BLM SCALAR FIX -Based on findbhudda's original design:
http://www.midibox.org/dokuwiki/doku.php?id=findbuddha

DESIGN FILES:
Corrected blm-scalar v1.1.brd blm-scalar_v1.1.brd.zip

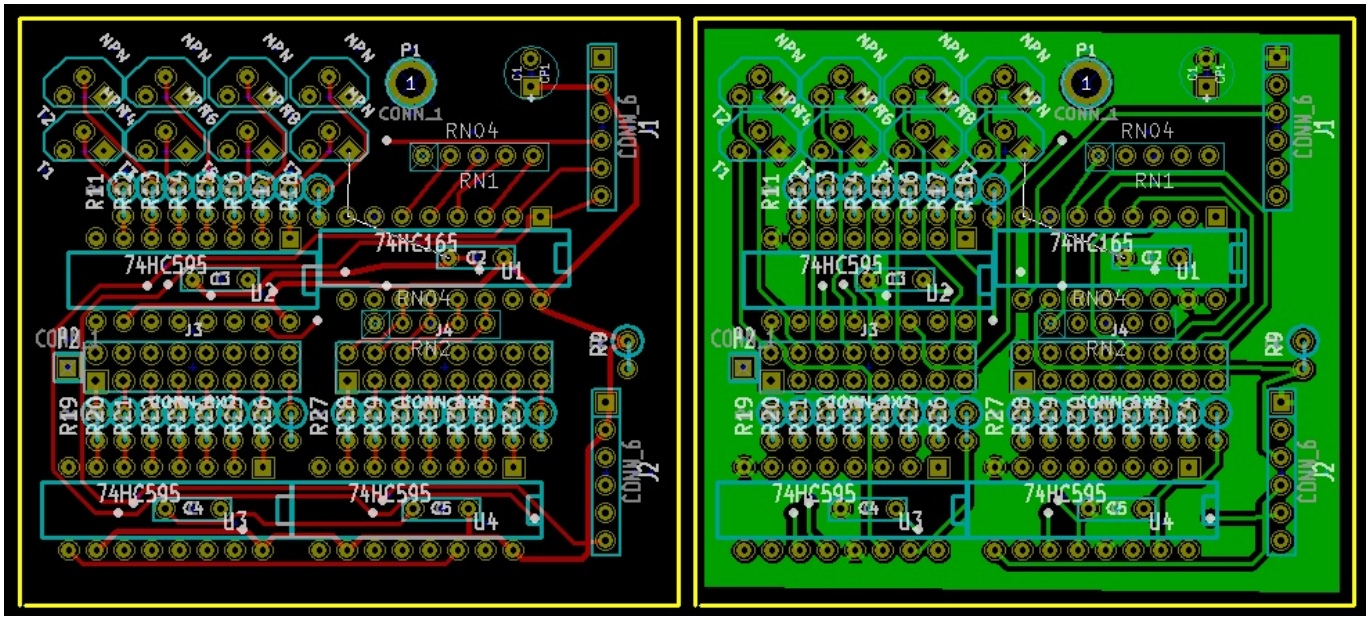
KNOWN ISSUES / BUILD SUGGESTIONS:
- blm-scalar.* contain an error. Pins I4-I7 are mirrored. This is easily fixed with a connector modification, and the blm-scalar module seems to work as intended.
- blm-scalar v1.1 attempts to fix this error. Moved connectors J1, J2, Resistor Net 1 and R9 to make room for corrections.
